**Seagate Technology**

Subject: Slow DT Timing Revision Proposal for SPI-3

**Table 1 - SCSI bus data & information phase Double Transition timing values**

## DT SETUP AND HOLD TIMINGS FOR DT DATA TRANSFER

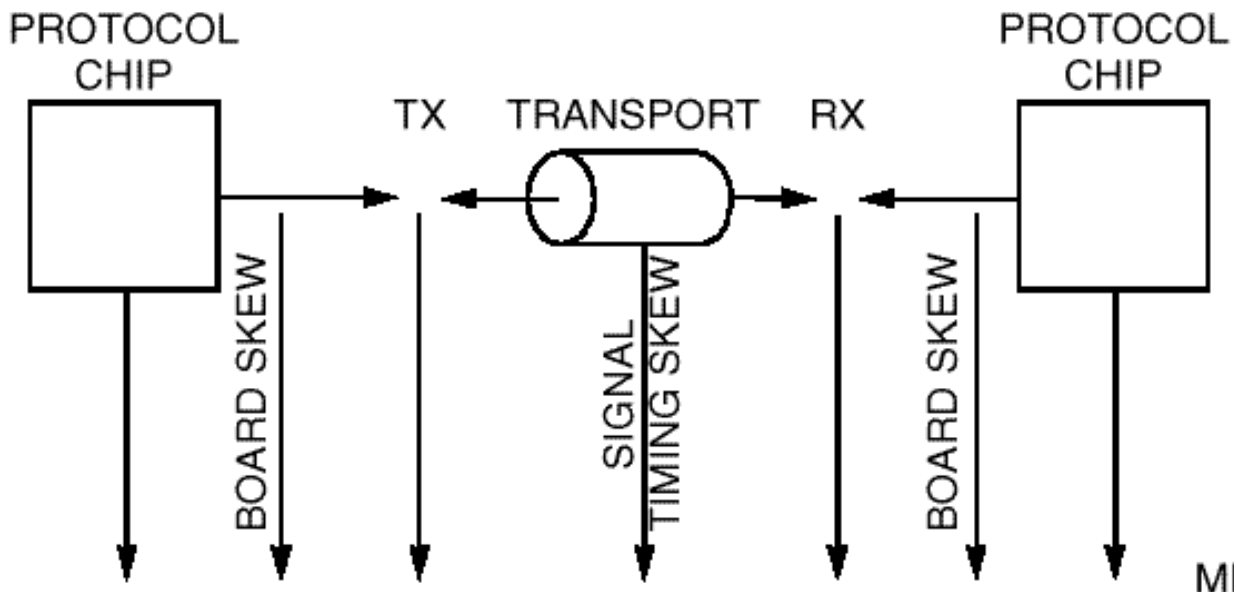
The analysis and the working group discussions concluded that the slower DT timing would work but the specifications were inconsistent with the Fast 80 methodology and should be revised to be more consistent with this methodology. The present SPI-3 slower DT timing is adopted from Single Transition (ST) timing while the last presentation I made and the working group conclusion was to start with the Fast 80 specifications and double the allotments as the transfer rate is halved. The bulk of the working group concluded the printed circuit allocation should be constant but an influential member of the working group requested that the printed circuit allocation be increased with the lower transfer rates. I have decided in the attached proposal to accommodate the influential member. Finally the last working group agreed that the analysis should be converted to a proposal.

The ATN and CRC receive times have been adjusted for the slow categories to account for the above revision of the Signal Skew Timing values.

Based upon the working group conclusions I have generated the following proposed replacements in SPI-3:

(ALL TIMES IN ns)

Timing Mode \_\_\_\_\_ Minimum

Fast 80

(6,25 IDEAL) 5,0 \_ 0,2 \_\_\_\_\_ 4,8 \_\_\_\_\_ 3,35 \_\_\_\_\_ 1,45 \_ 0,2 \_ 1,25 \_ Setup

(6,25 IDEAL) 5,0 \_ 0,2 \_\_\_\_\_ 4,8 \_\_\_\_\_ 3,35 \_\_\_\_\_ 1,45 \_ 0,2 \_ 1,25 \_ Hold

Fast 40

(12,5 IDEAL) 10,0\_ 0,4 \_\_\_\_\_ 9,6 \_\_\_\_\_ 6,7 \_\_\_\_\_ 2,9 \_\_\_ 0,4 \_ 2,5 \_ Setup

(12,5 IDEAL) 10,0\_ 0,4 \_\_\_\_\_ 9,6 \_\_\_\_\_ 6,7 \_\_\_\_\_ 2,9 \_\_\_ 0,4 \_ 2,5 \_ Hold

Fast 20

(25 IDEAL) \_ 20,0\_ 0,8 \_\_\_\_\_ 19,2 \_\_\_\_\_ 13,4 \_\_\_\_\_ 5,8 \_\_\_ 0,8 \_ 5,0 \_ Setup

(25 IDEAL) \_ 20,0\_ 0,8 \_\_\_\_\_ 19,2 \_\_\_\_\_ 13,4 \_\_\_\_\_ 5,8 \_\_\_ 0,8 \_ 5,0 \_ Hold

Fast 10

(50 IDEAL) \_ 40,0\_ 1,6 \_\_\_\_\_ 38,4 \_\_\_\_\_ 26,8 \_\_\_\_\_ 11,6 \_\_\_ 1,6 \_ 10,0 \_ Setup

(50 IDEAL) \_ 40,0\_ 1,6 \_\_\_\_\_ 38,4 \_\_\_\_\_ 26,8 \_\_\_\_\_ 11,6 \_\_\_ 1,6 \_ 10,0 \_ Hold
